UPDATED MEETING POSTING

Committee/Board/s | Nantucket Historical Commission

Day, Date, and Time | Friday, May 21, 2021 at 10:00 AM

Stantec Response

Figure 12 – Several Historic Cross Sections of Stone Pavements.
In Garilli and Giuliani, original period details from Cantalupi,⁹ 1886 (top two images)
Lanino, 1898 (bottom two images).

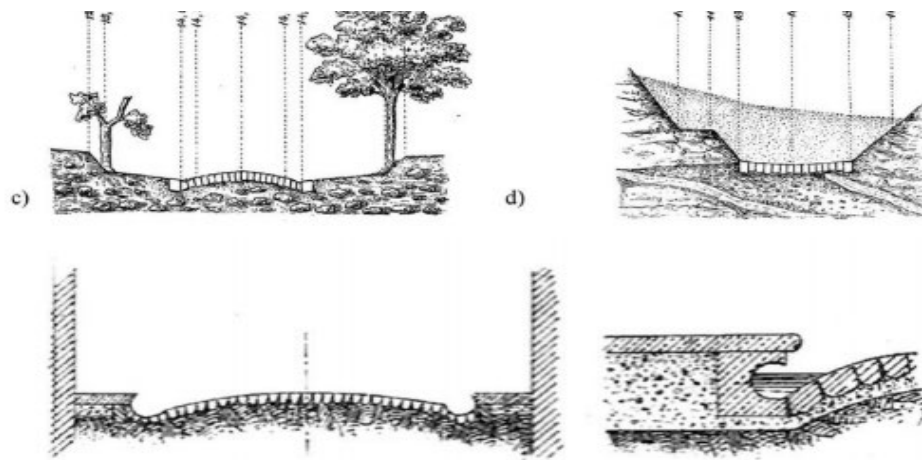
Note, pavement crown for drainage runoff and use of uniform sized, rectangular pavers with tight joints.

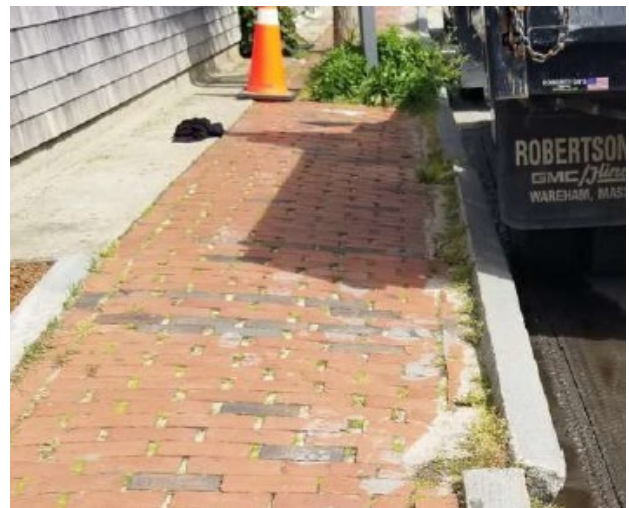
6. NHC Report Recommendation – Curbs require a strong support to resist turning over...

- Concur. Support for stone curbs is provided using Massachusetts DOT standard drawing E 106.3.0 download ([mass.gov](https://www.mass.gov)) page 22, with additional concrete on backside of the curb to stabilize shallow curbs. This technique was specified due to proven performance and re-use of existing shallow curb stones. Resistance to dislodging is necessary, as errant wheel impacts can dislodge the stone curbs if they are not secured by the concrete. The concrete support referenced above is open at the bottom and is not U shaped. Water is able to drain through to the base.

- U shaped concrete saddles are not used to support the stone curbs. As noted in the report, U shape saddles may act as an 'ice cube tray', trapping water/moisture in the saddle with the potential for freezing and cracking. Freeze thaw of water in the saddle and the potentially saturated schist a metamorphic stone can cause deterioration. We do not recommend following this methodology.
